**RESPONSE TO U.S. AND OHIO EPA QUESTIONS ON K-65 SILO INTERIM
REMEDATION**

**DOE-1308-89
DOE-FMPC USEPA
33
RESPONSES**

RESPONSE TO U. S. AND OHIO EPA QUESTIONS ON K-65 SILO INTERIM REMEDICATION

Work Plan for the K-65 Silos Interim Stabilization Project

RADIATION SURVEY AND 5565 TYPICAL AIR MONITORING LOCATIONS

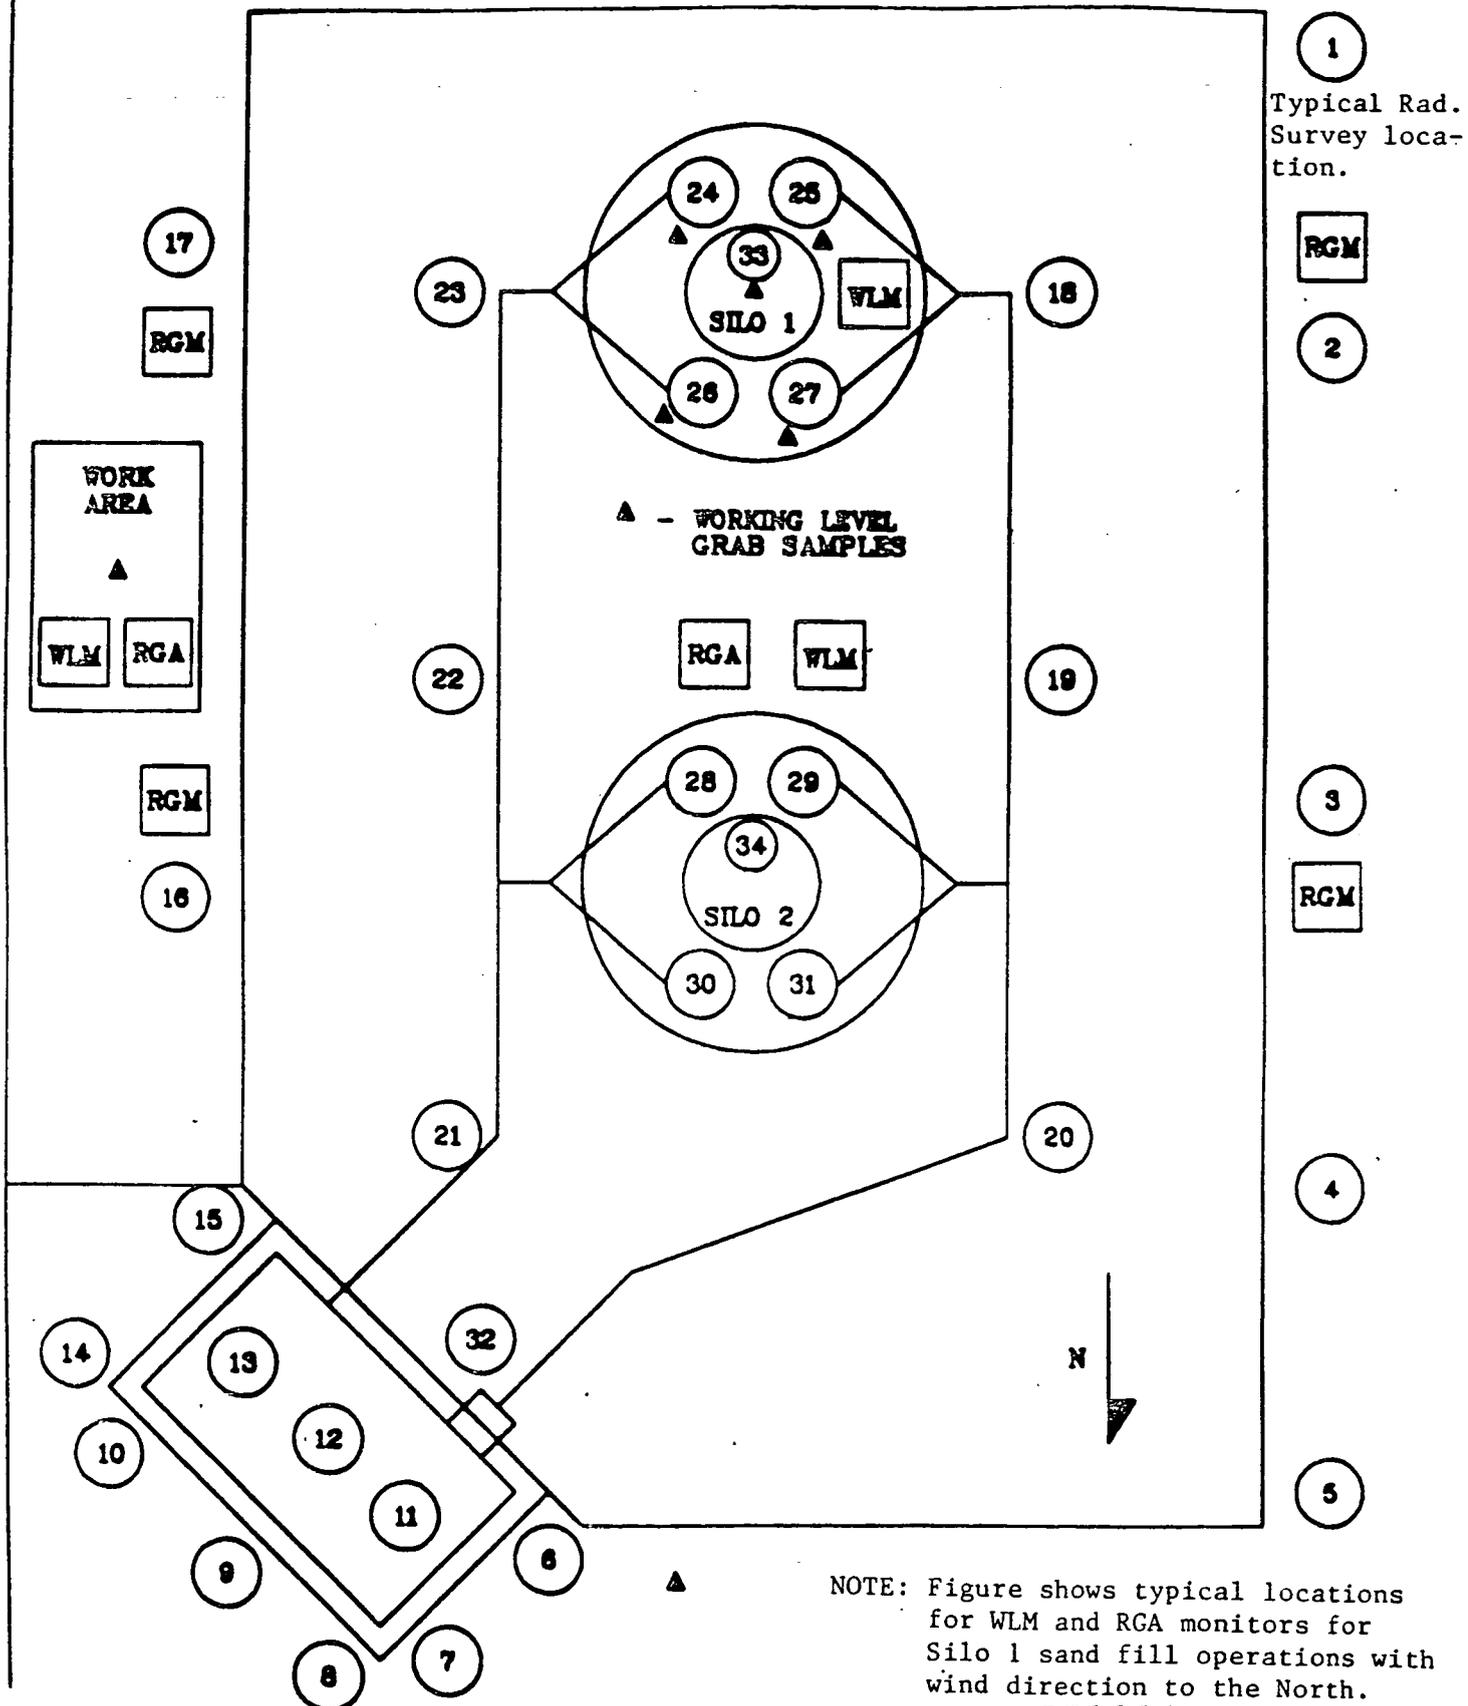
Comment 6: "Attachment 1, Page 2, Item 3: The "downwind" direction is dynamic. Monitors should be installed in four directions to compensate for shifting downwind directions."

Comment 10: "Figure 3.1.1, Section 7.3: Radon monitors should be placed in all four major compass directions. A monitor is not currently proposed in the southerly direction."

Response: The "Work Plan for the K-65 Silos Interim Stabilization Project - Installation of Sand Layer", Figure 7.0 - Radiation Survey and Typical Air Monitoring Locations shows the locations of all proposed monitoring equipment (Attachment 2).

As a part of the FMPC environmental monitoring program continuous radon gas monitoring is conducted at the K-65 Silo fence line using alpha scintillation devices known as Radon Gas Monitors (RGM-2). The location of the RGMs are approximately east and west of each of the K-65 Silos. The locations of the monitors, and the monitoring data obtained from the monitors, are included in the Feed Materials Production Center Environmental Monitoring Annual Report.

In addition to the current monitoring program, three Working Level Monitors (WLM) and two continuous Radon Gas Analyzers (RGA-40) will be used during the sand installation. One of the WLM units will be placed on the silo dome, one WLM will be placed on the top of the earthen berm, and the third WLM unit will be placed at the work area. For the RGA-40 units, one will be placed at the top of the earthen berm and the second unit will be placed in the work area during the sand installation. The WLM and RGA-40 units will be located downwind in their respective positions during the sand fill operations.

It is felt that the existing FMPC environmental monitoring program monitoring equipment, in conjunction with the additional monitoring proposed for this project, is effective in providing monitoring during the project. Technicians will be at the work site to monitor the wind directions and will locate the monitoring units as described. Based on the discussion of this item with the EPAs this item is considered closed.
